CITY OF PORTLAND, MAINE
HISTORIC PRESERVATION BOARD

HISTORIC PRESERVATION BOARD AGENDA
April 15, 2015, 5:00 p.m. - Room 209, Portland City Hall

**PUBLIC HEARING
276 STATE STREET**

RE: April 15, 2015 Public Hearing - Review of Proposed Rooftop Addition

FIRST FLOOR PLAN

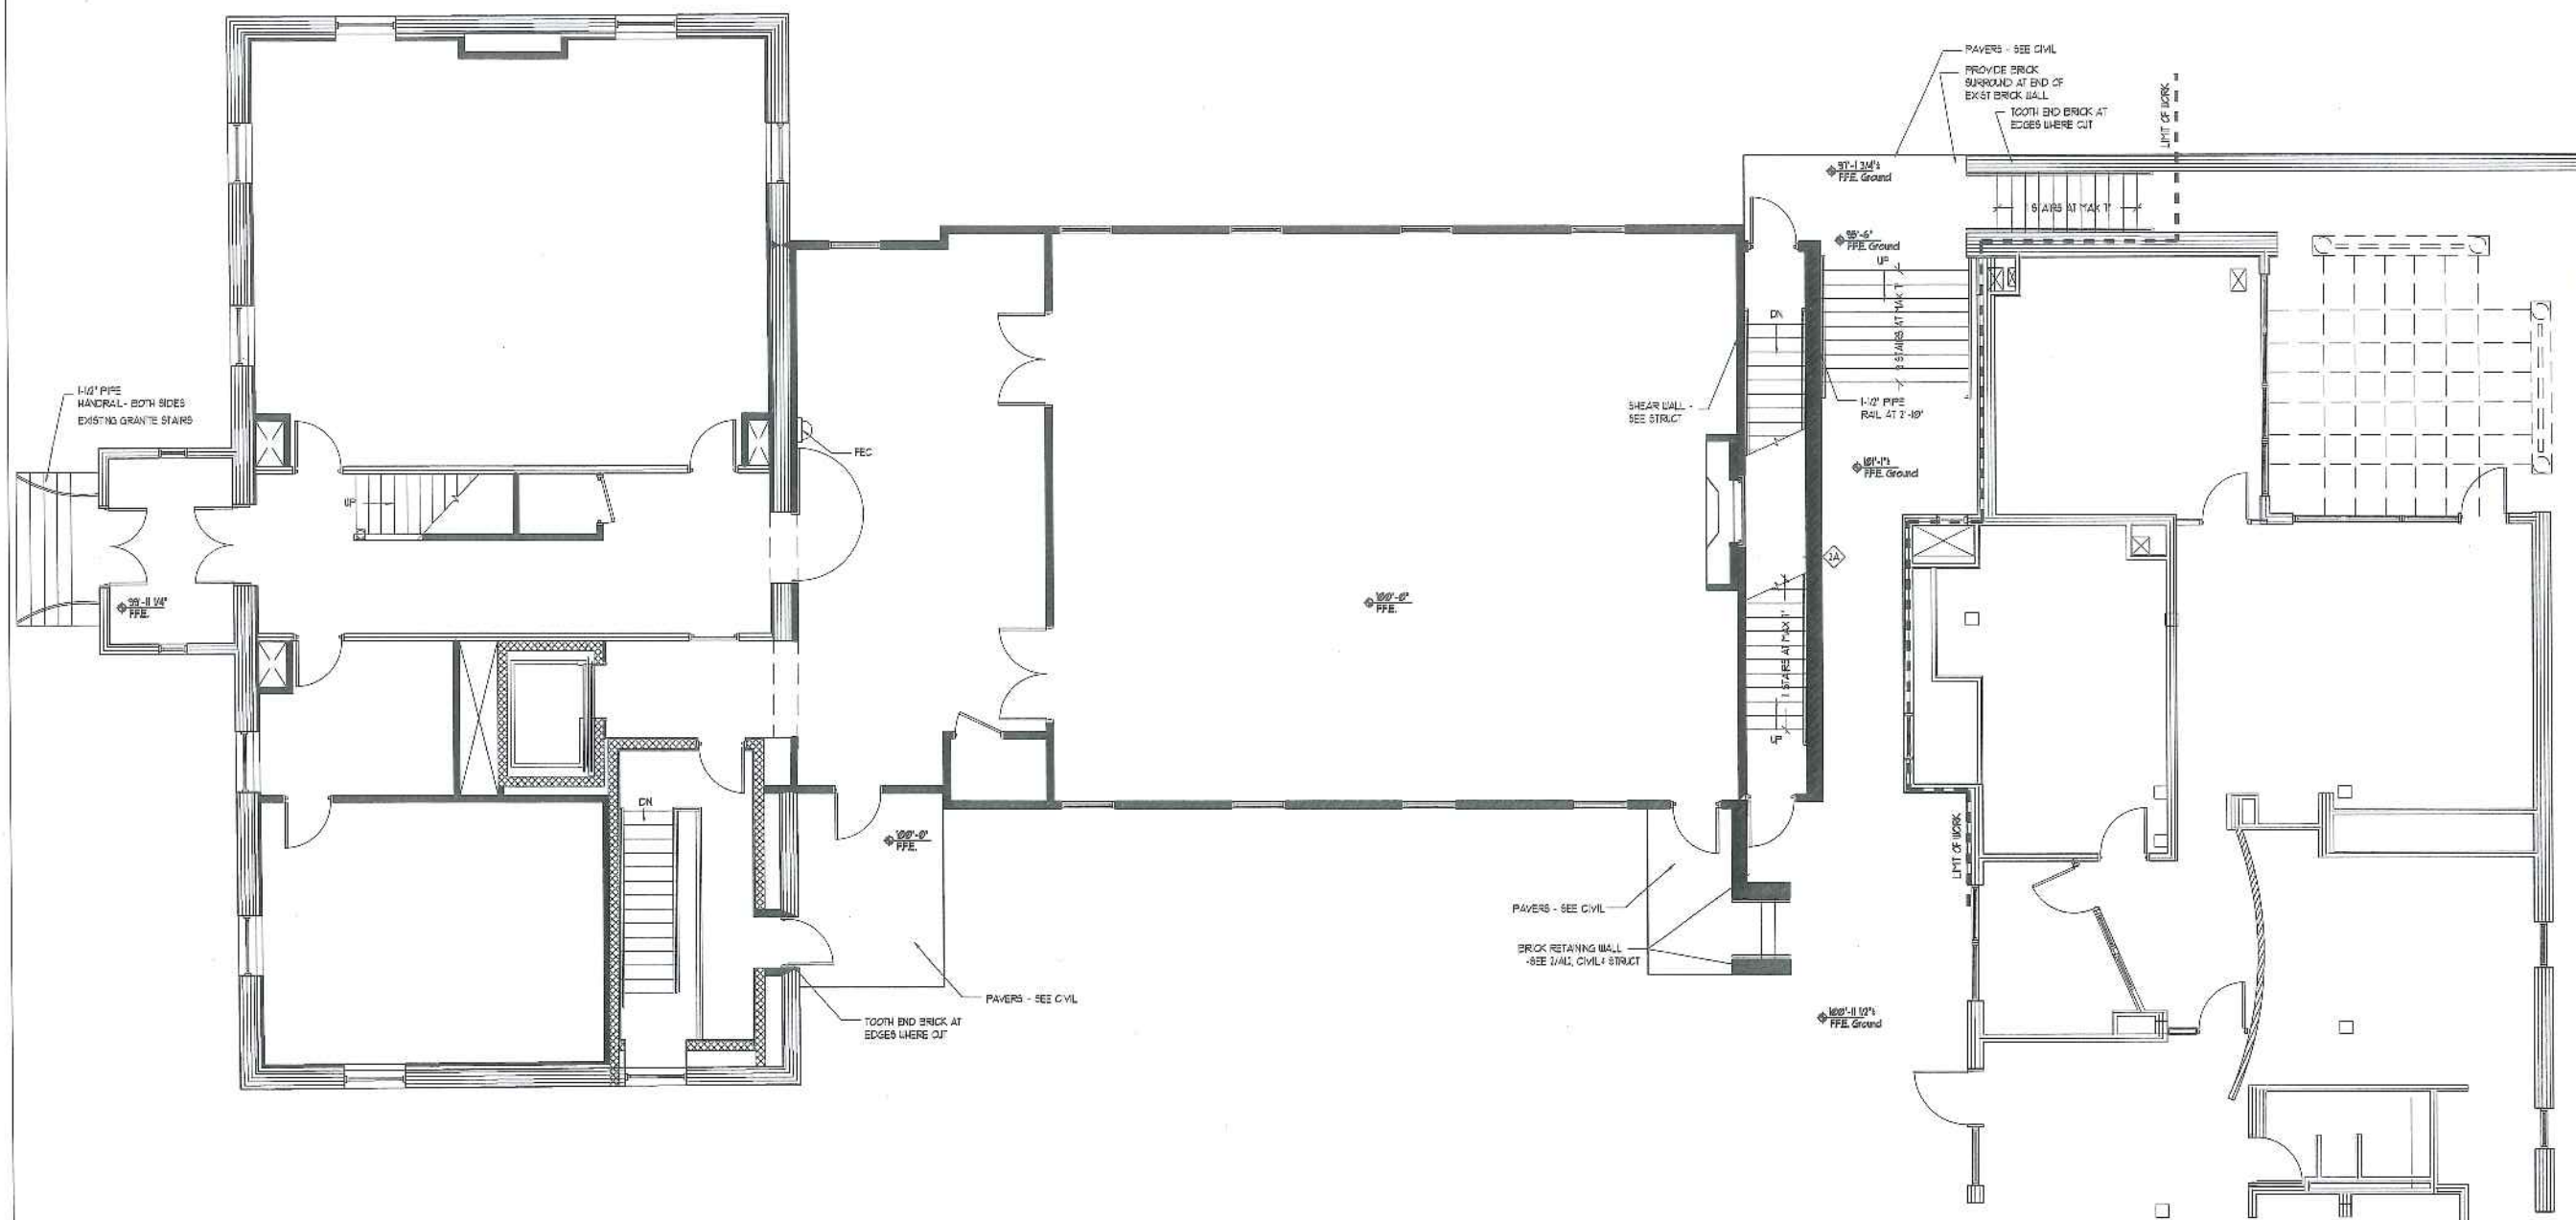
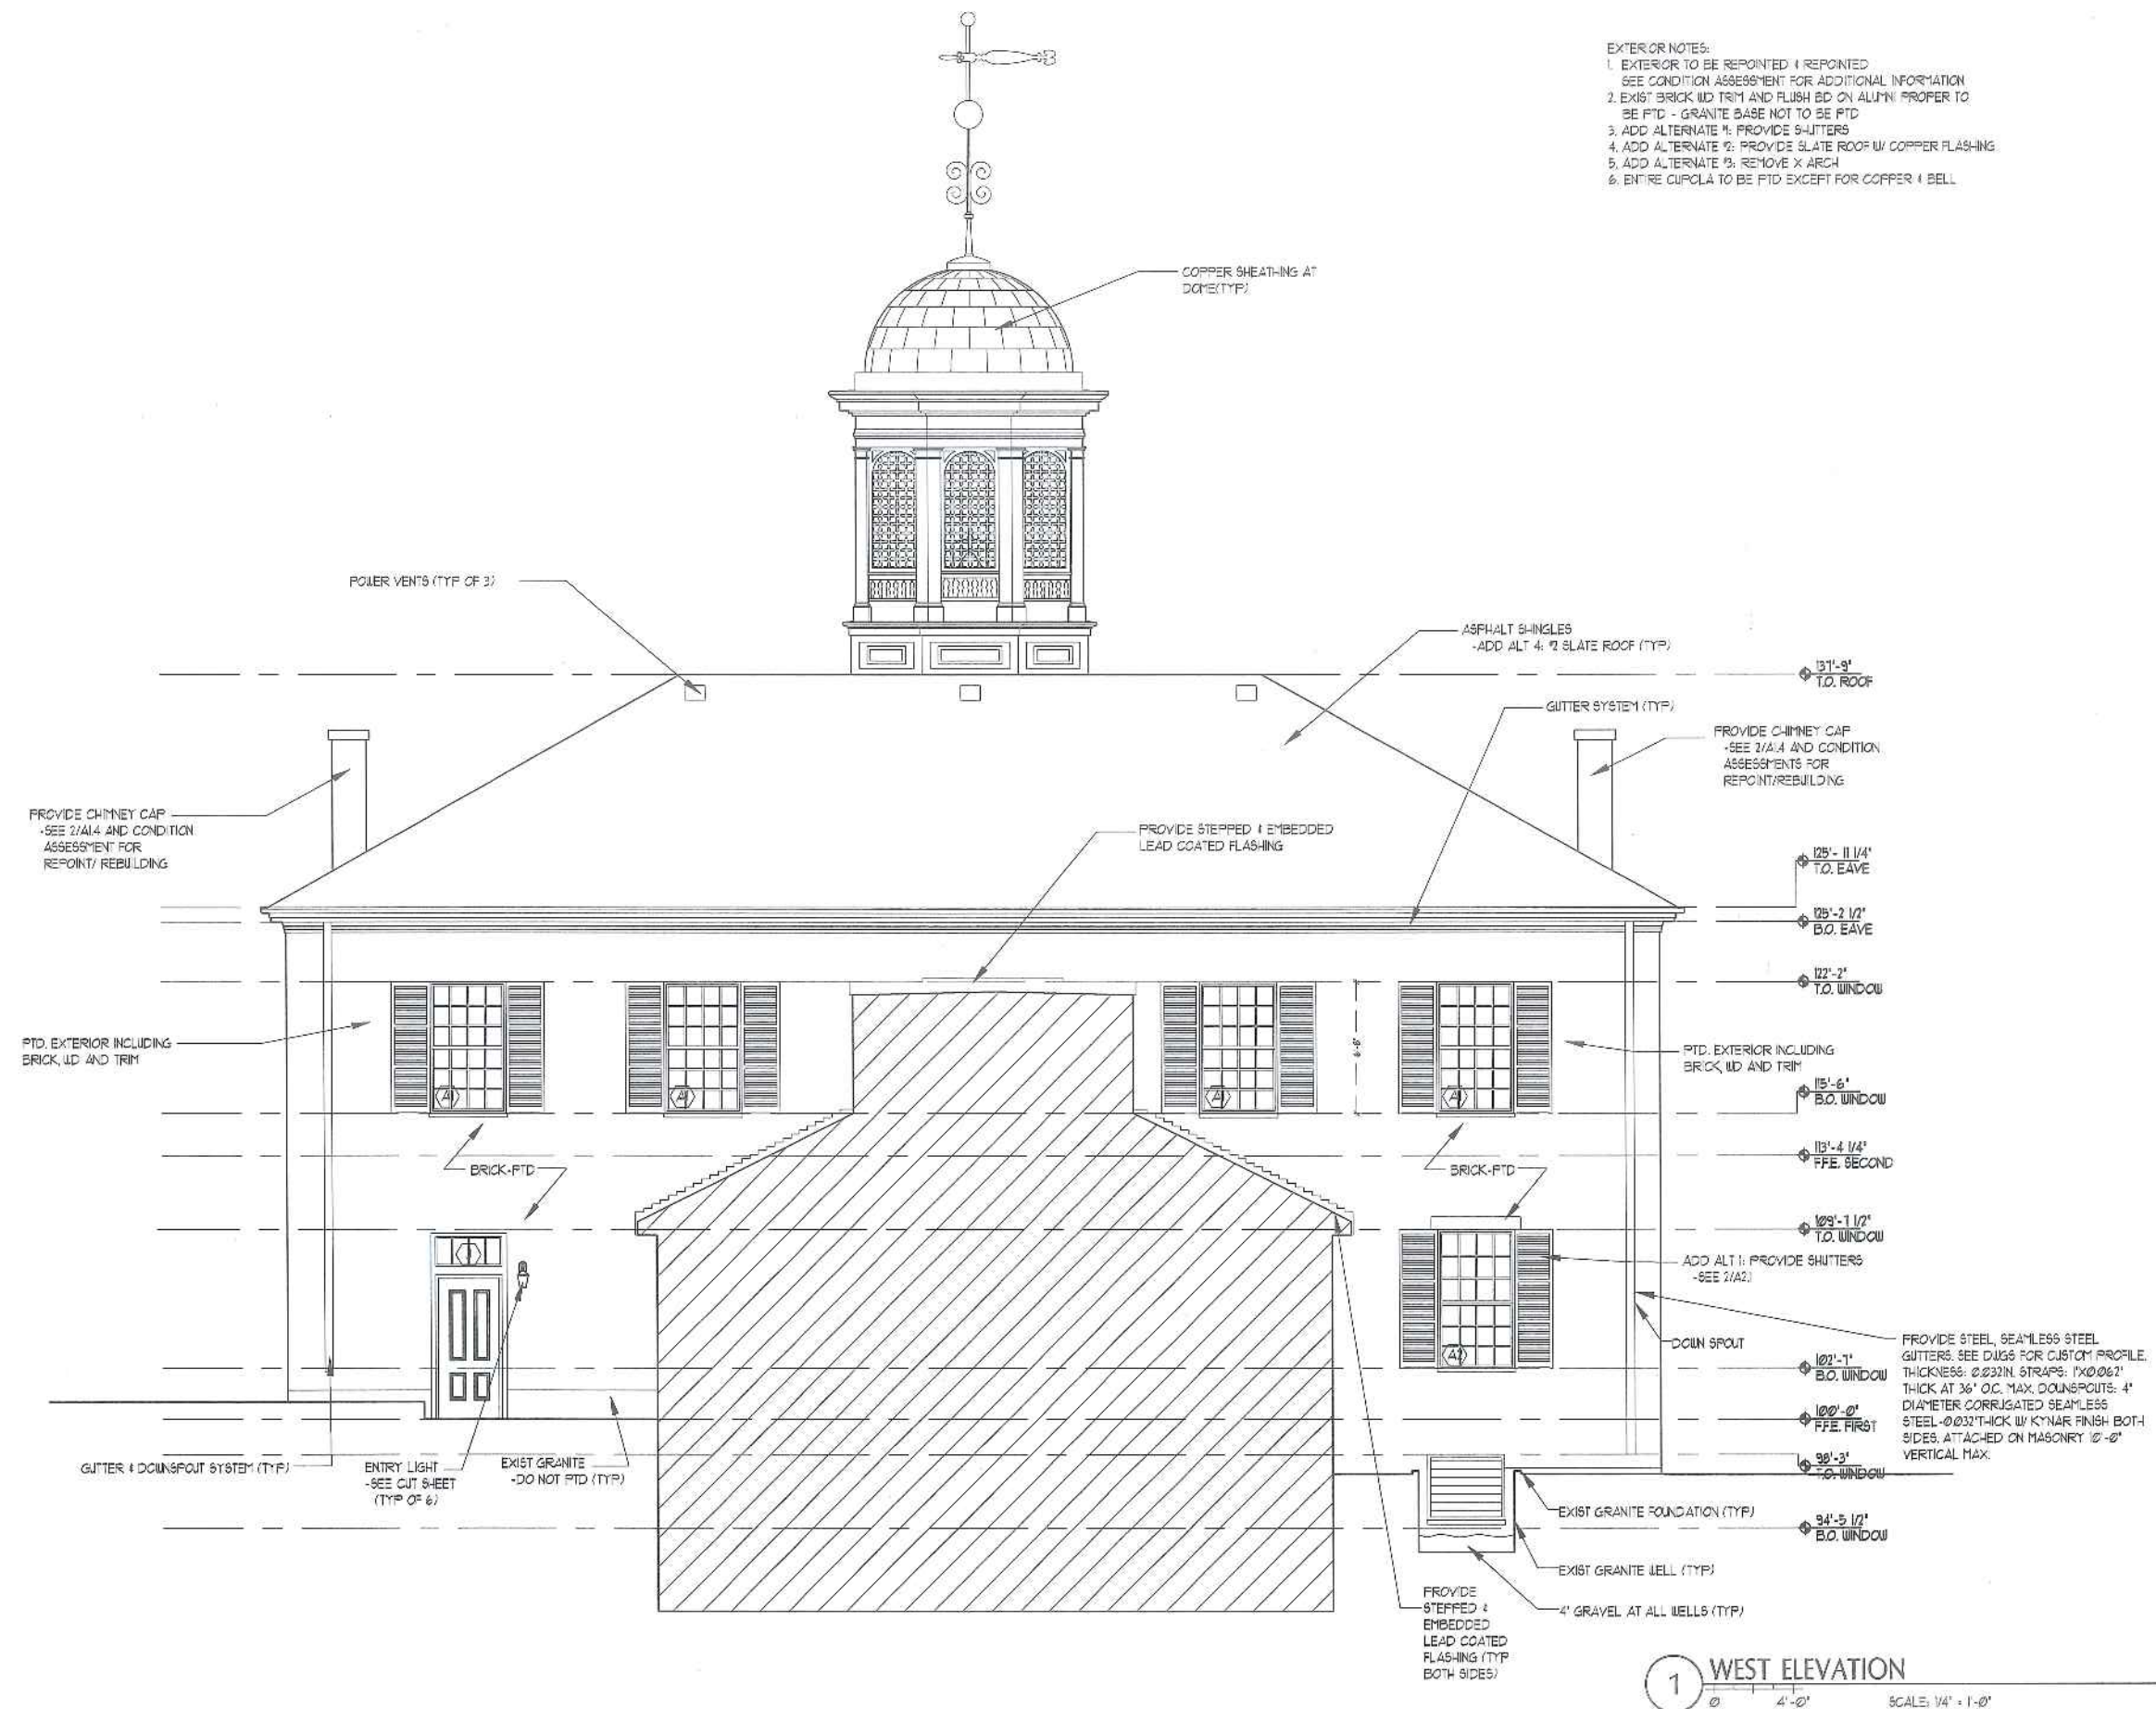
This revised design was then presented to the University of New England's Board of Trustees on March 20, 2015. While they appreciated the efforts of the redesign, they were not able to approve the flat roof on the addition, and asked that we go back to the drawing board and seek alternatives to the design that would allow for the roof of the addition to remain peaked as it currently exists, without increasing the mass of the addition. This revised design is attached for your review.

As you can see, in this new design the roof line of the addition is now peaked, yet remains at a height similar to the existing structure. This was achieved by relocating both the second egress stair and the elevator within the masonry portion of Alumni Hall. Additionally, as a result of this redesign, we were able to further reduce the size of the connectors of the addition to Alumni Hall and Abplanalp Library.

We believe that this design is consistent with the previous approval of the HPB and even more closely meets their stated opinions of the design. We respectfully request that this redesign be approved as a de minimis change to the previous approval we received on March 18, 2015.
